Subject: Virgil C. Summer Nuclear Station (VCSNS) Units 2 and 3 Combined License Application (COLA) - Docket Numbers 52-027 and 52-028 Supplement 2 Response to NRC Request for Additional Information (RAI) Letter No. 032

SRP Section: 2.5.4 – Stability of Subsurface Materials and Foundations

NRC RAI Number: 02.05.04-13

Figures 02.05.04-13.1 through 02.05.04-13.8

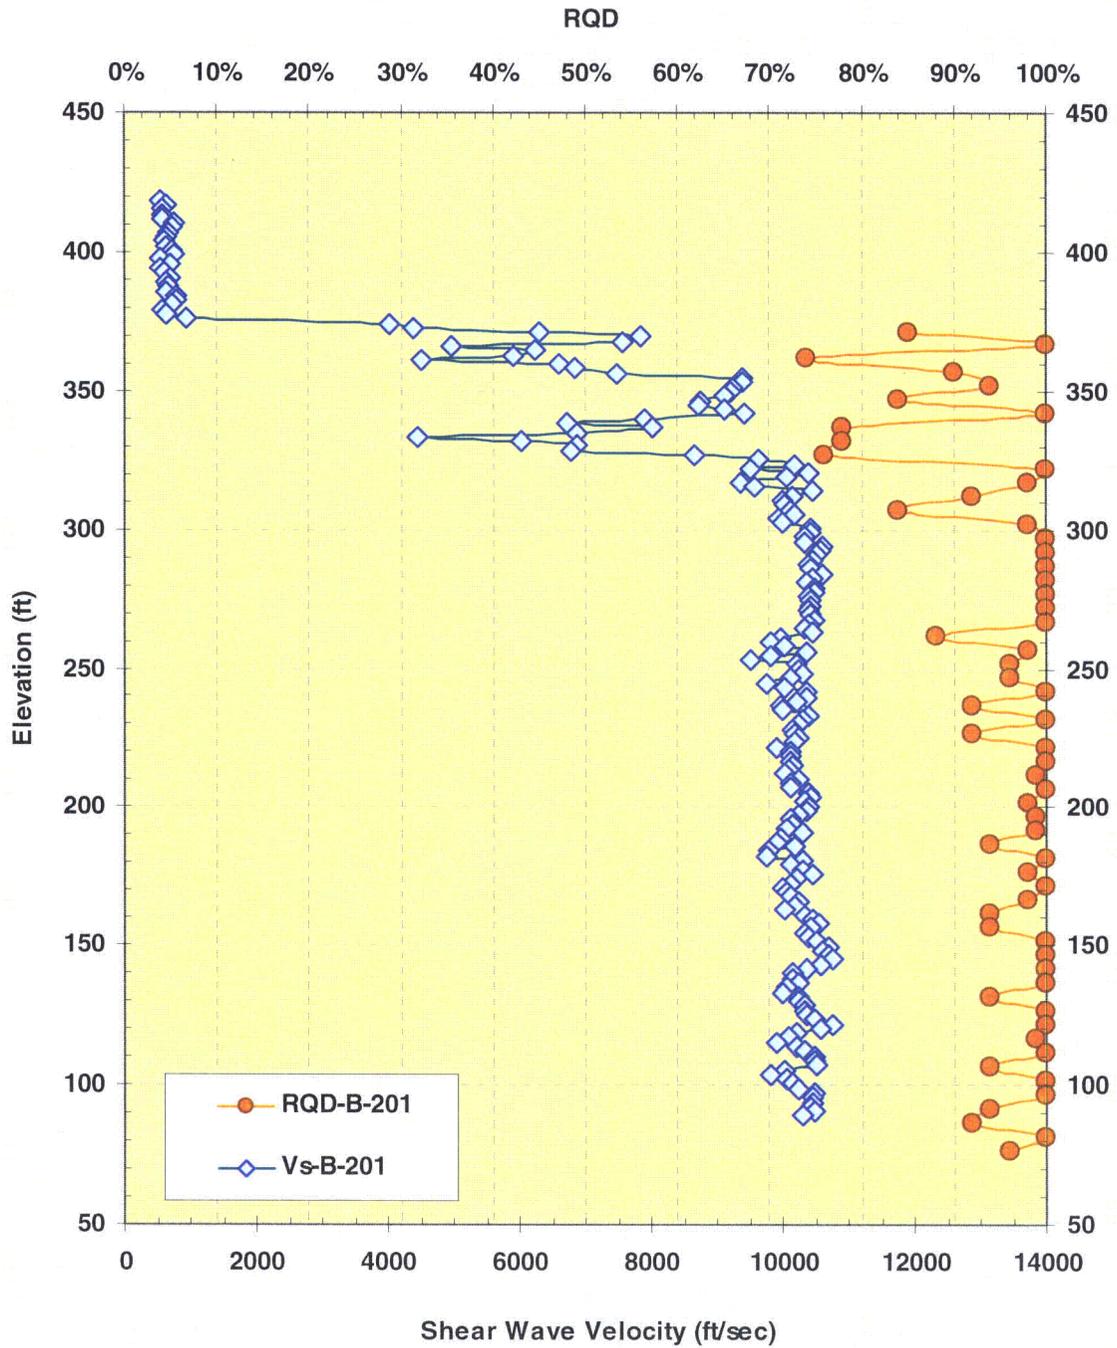
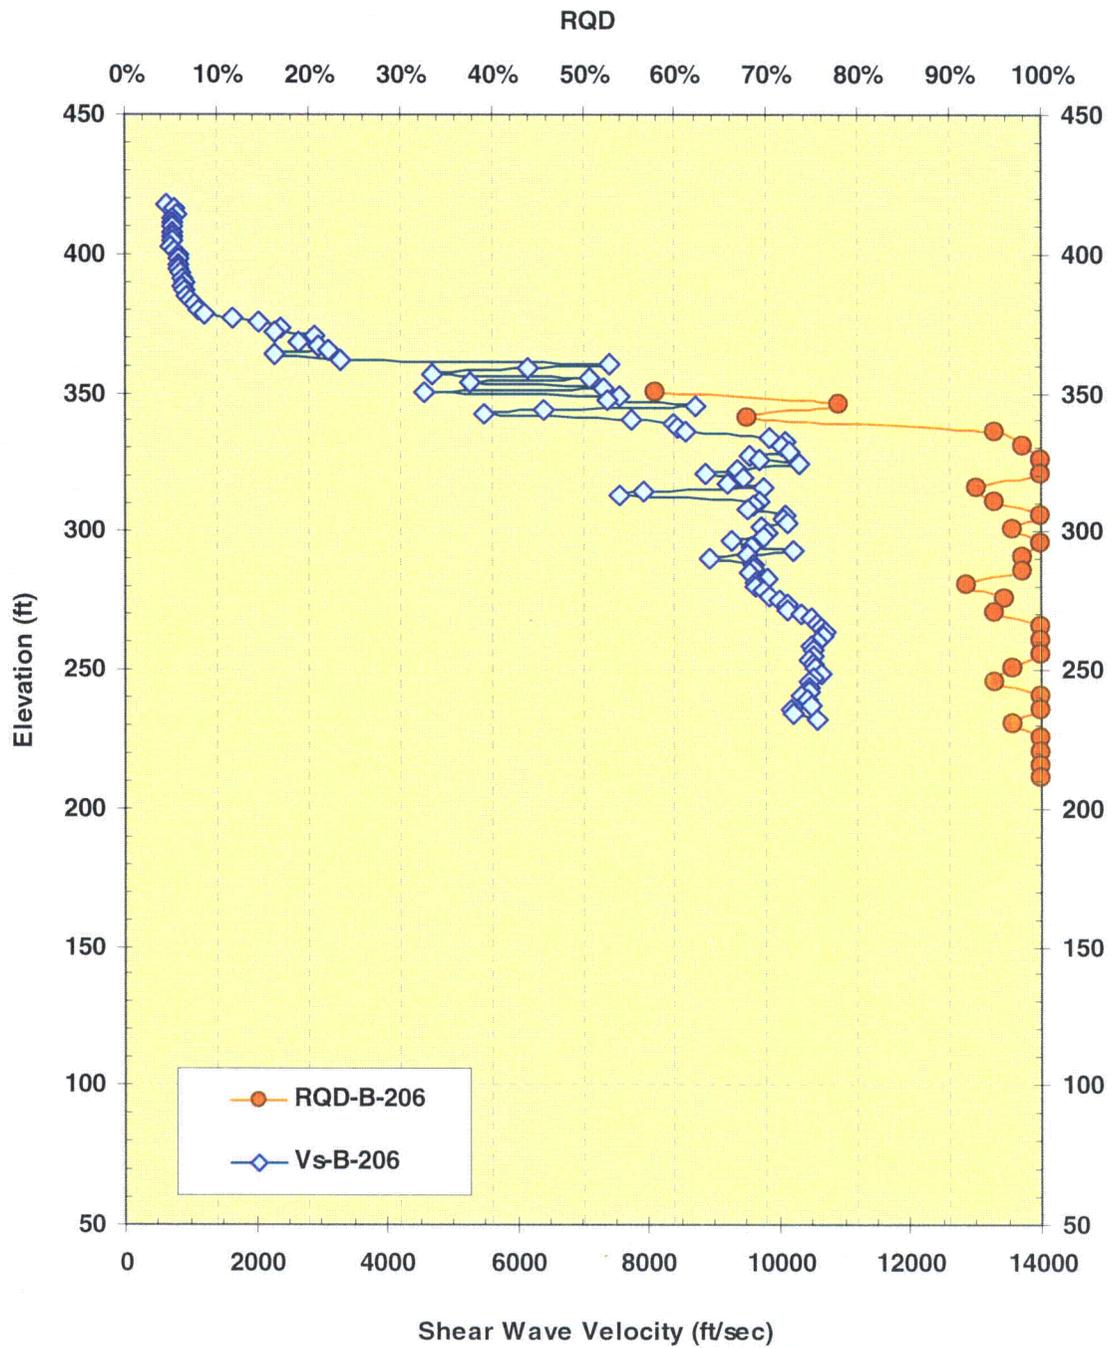
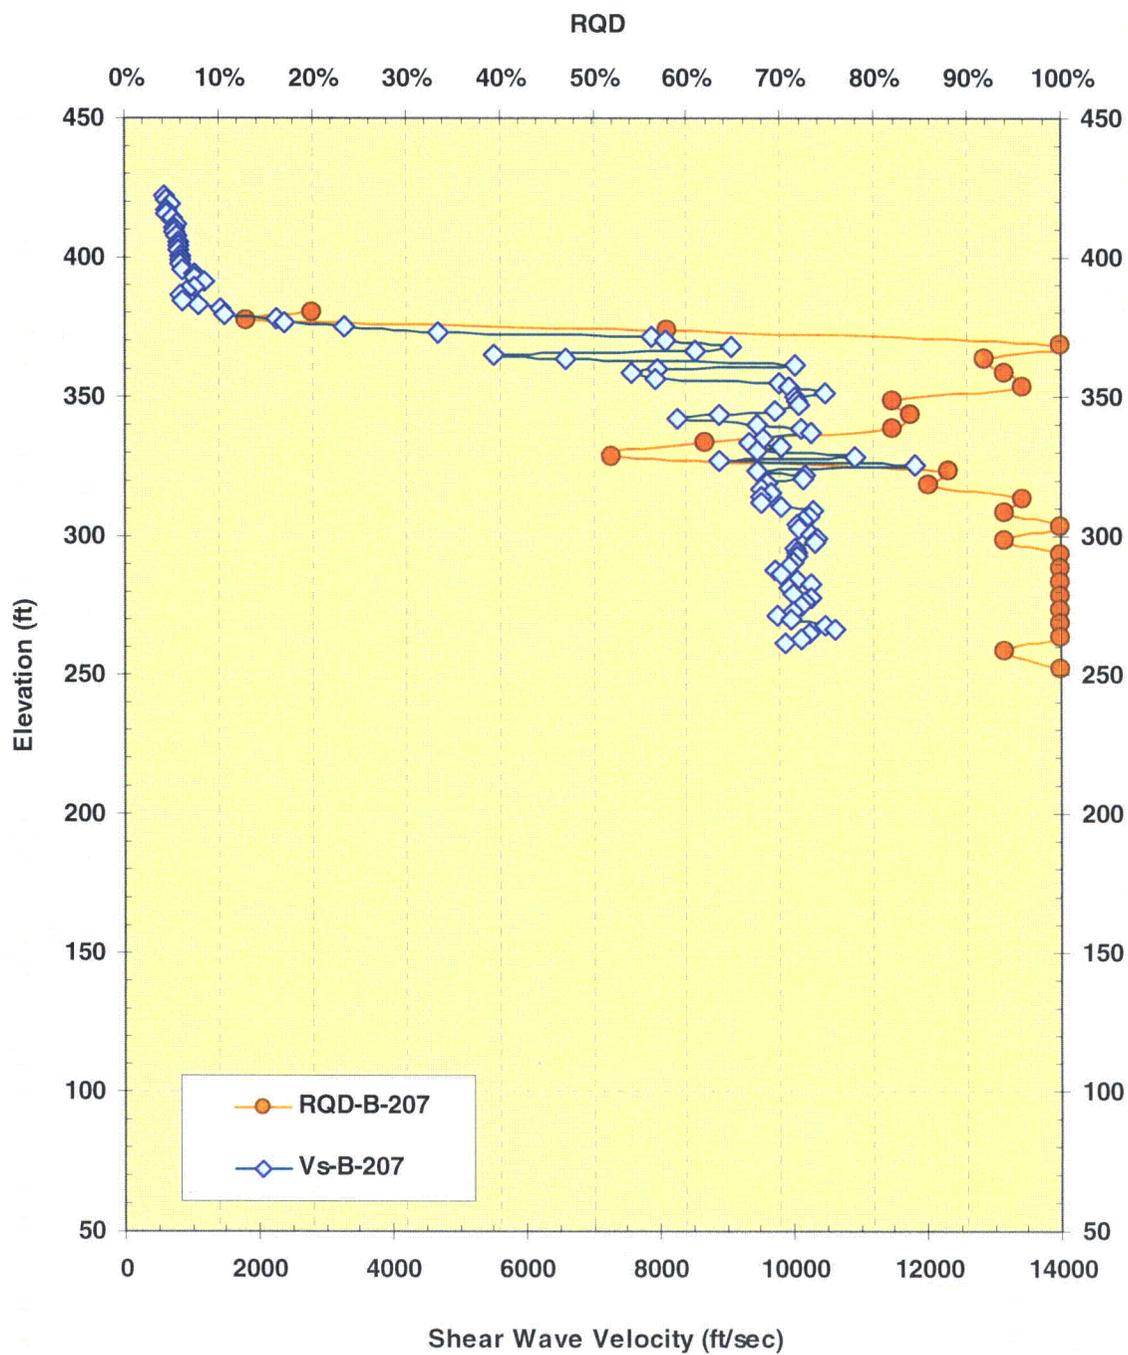
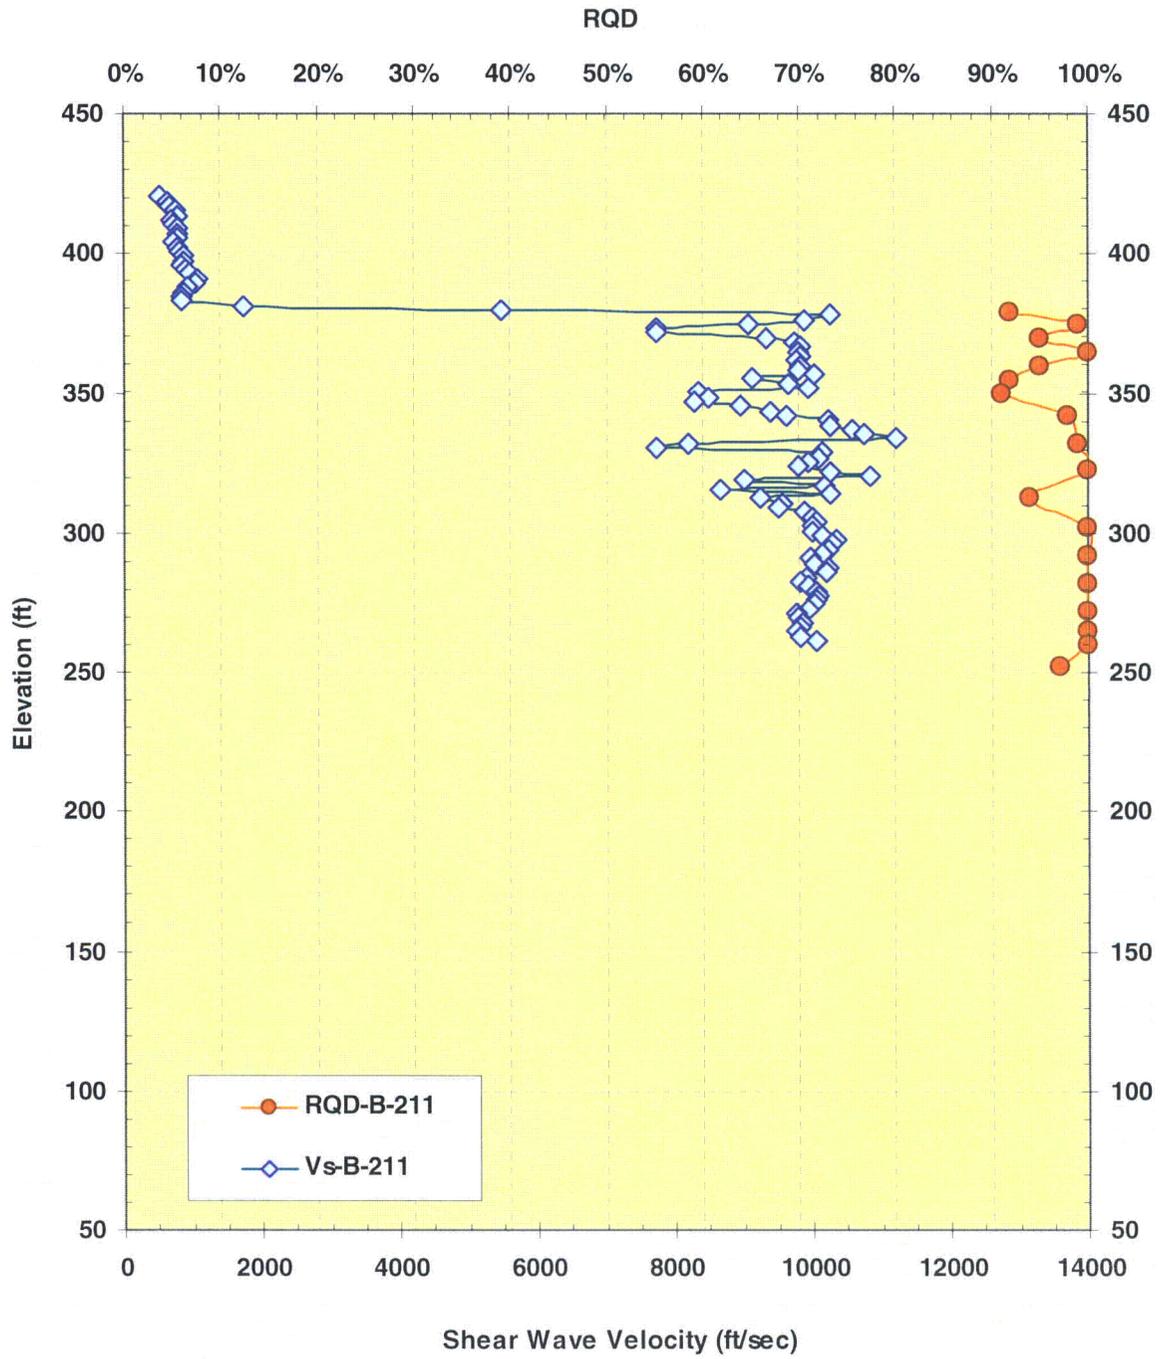
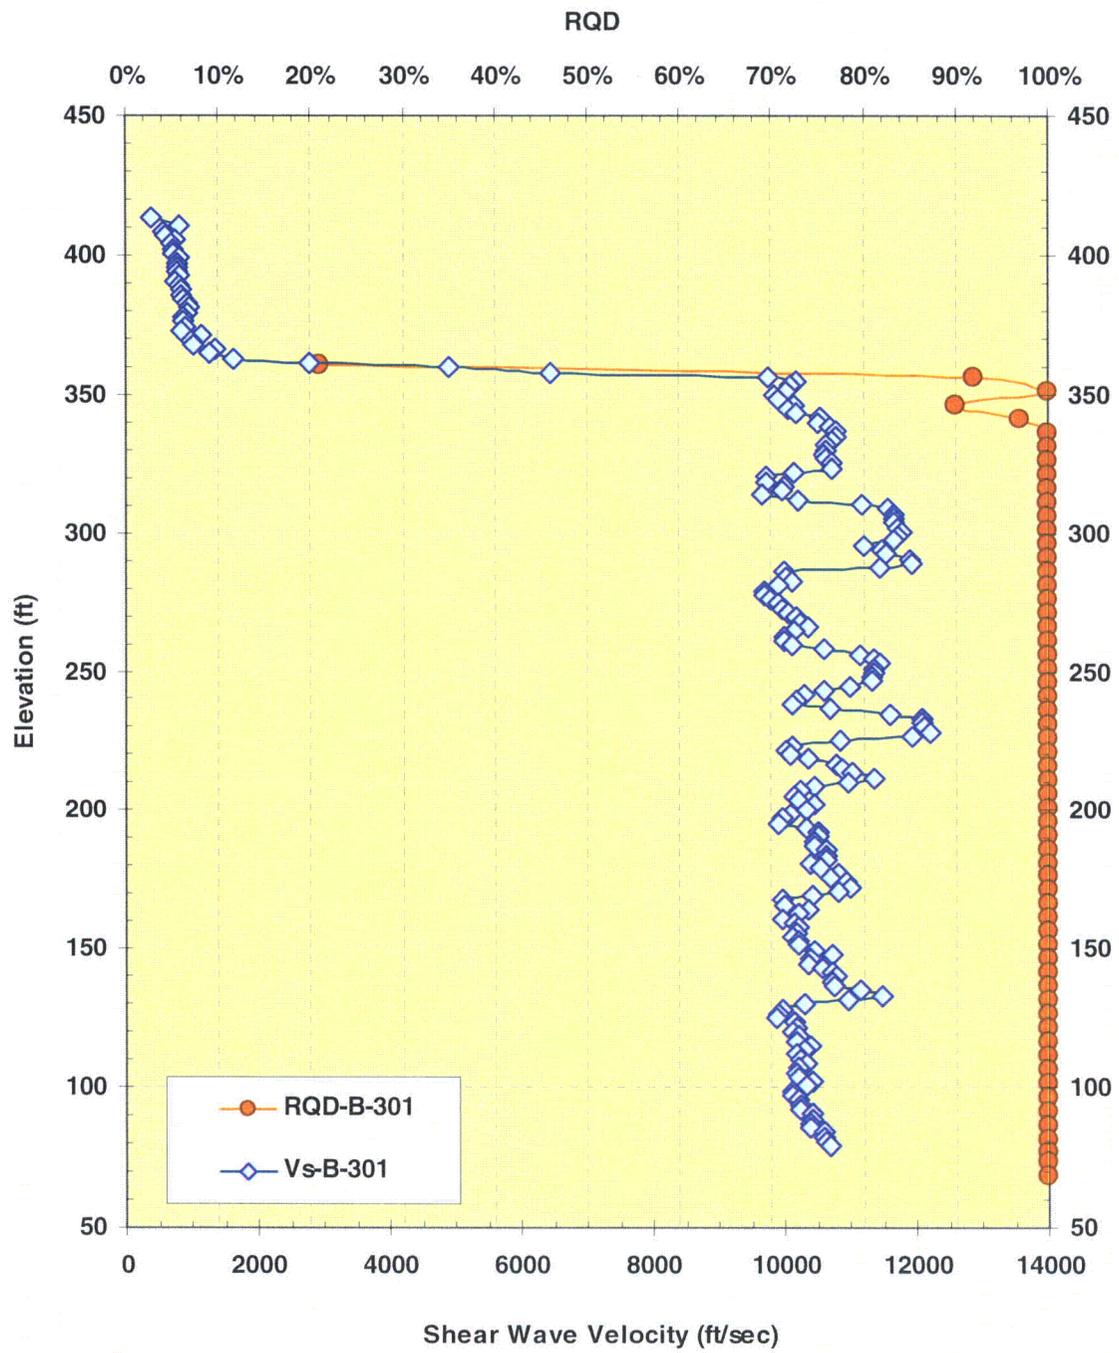
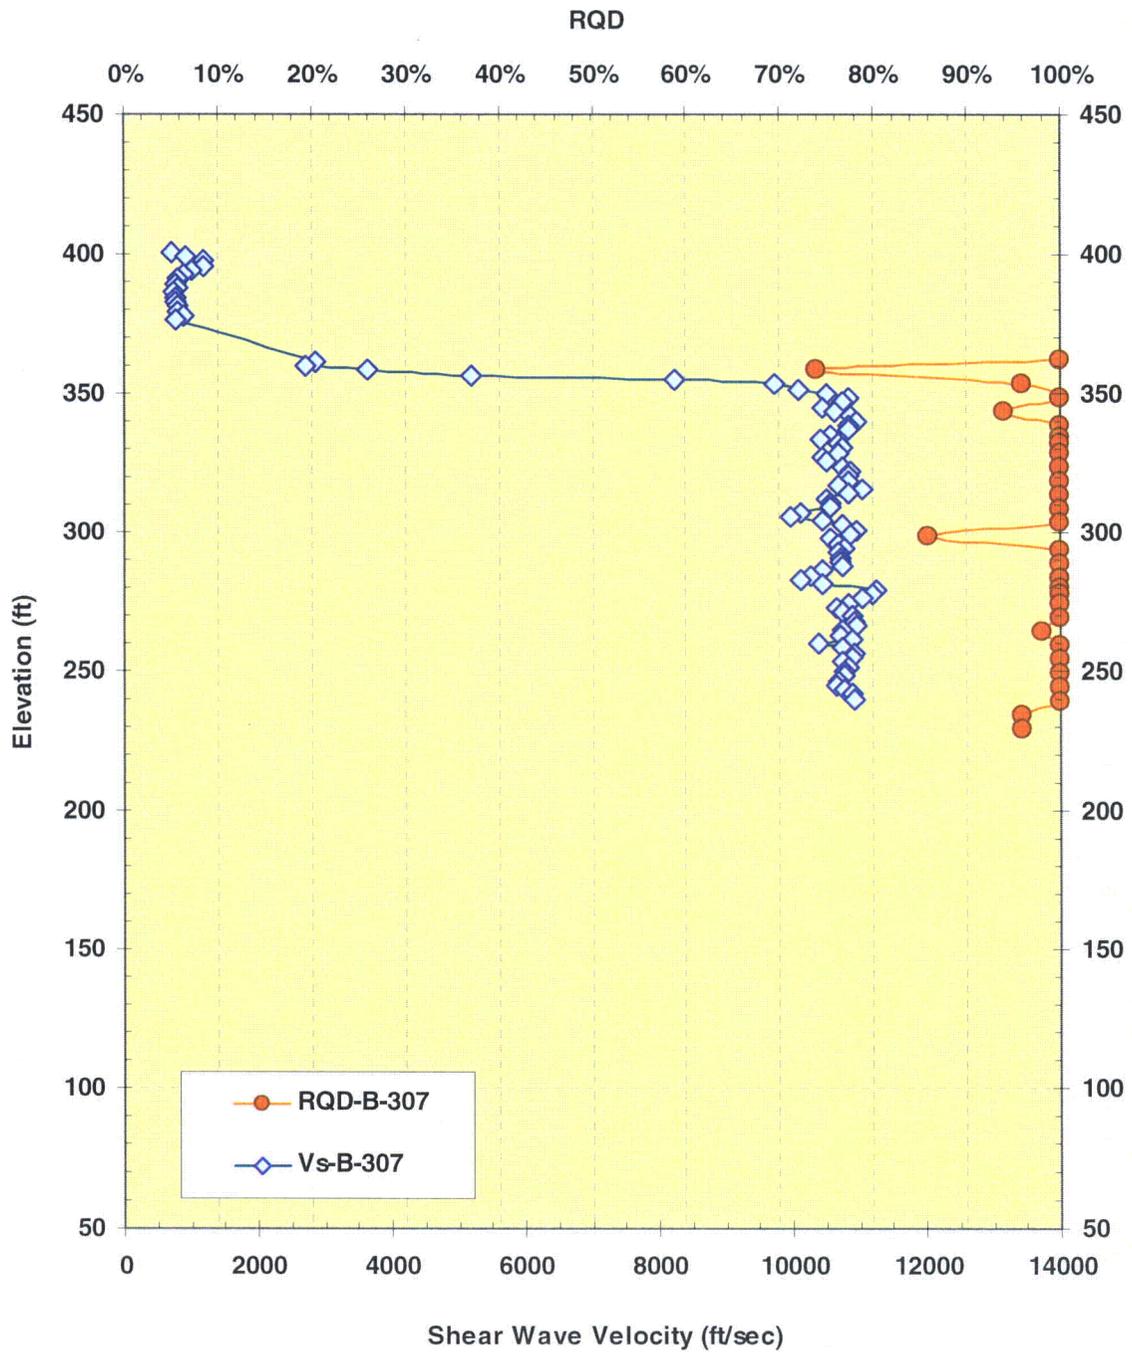
FSAR Section 2.5.4.2.2.1 indicates that the top of Layer V (sound rock) was based on estimates of RQD from the available boring samples as well as measured shear wave velocities determined from the suspension logger. Table 2.5.4-201 indicates that the top of Layer V can vary from as low as elevation 335' to as high as elevation 360'. Figure 2.5.4-211 indicates that measured RQD for sound rock varies from as low as 20% up to 100% with average RQD values exceeding 50%. Please provide information on the correlation of RQD with V_s as well as how average values were determined from the boring data for rock profiles that have such apparent non-uniformity with depth.

Attached are 8 figures that show RQD and V_s values obtained from the 8 boreholes in which the P-S suspension logger was used (4 in Unit 2 and 4 in Unit 3). Note that all of the measured RQD and V_s values are included in these figures, not just those of sound rock.

As noted in FSAR Section 2.5.4.2.2.1, sound rock was generally assumed when RQD exceeded 50%, but RQD values in sound rock were, in fact, typically over 70%. FSAR Table 2.5.4-209, Summary of Engineering Properties, shows RQD for Unit 2 to be in the 80% to 100% range, and RQD for Unit 3 to be in the 90% to 100% range. These Table 2.5.4-209 values are well illustrated in the figures, with only a few RQD values falling below 80% in the Unit 2 borings and even less falling below 90% in the Unit 3 borings. Very few rock cores were obtained in the MWR (RQD values less than 50%).

As would be expected, there is general correlation between RQD and V_s . In the Unit 2 borings, when RQD drops below about 80%, there is a noticeable reduction in V_s (except in B-207 around El. 330 ft, where no reduction in V_s was recorded). Similarly in the Unit 3 borings, when RQD drops below about 90%, there is a noticeable reduction in V_s .

Since there is no dip or bedding in the sound rock, the average values are based on 5 ft intervals of elevation. Note that in FSAR Figure 2.5.4-211(a), which includes values from 15 borings in Unit 2, there are a few RQD values less than 50%. In these cases, there was nothing in the core description to indicate partial or moderate weathering (PWR or MWR) and so the cores were counted as sound rock.
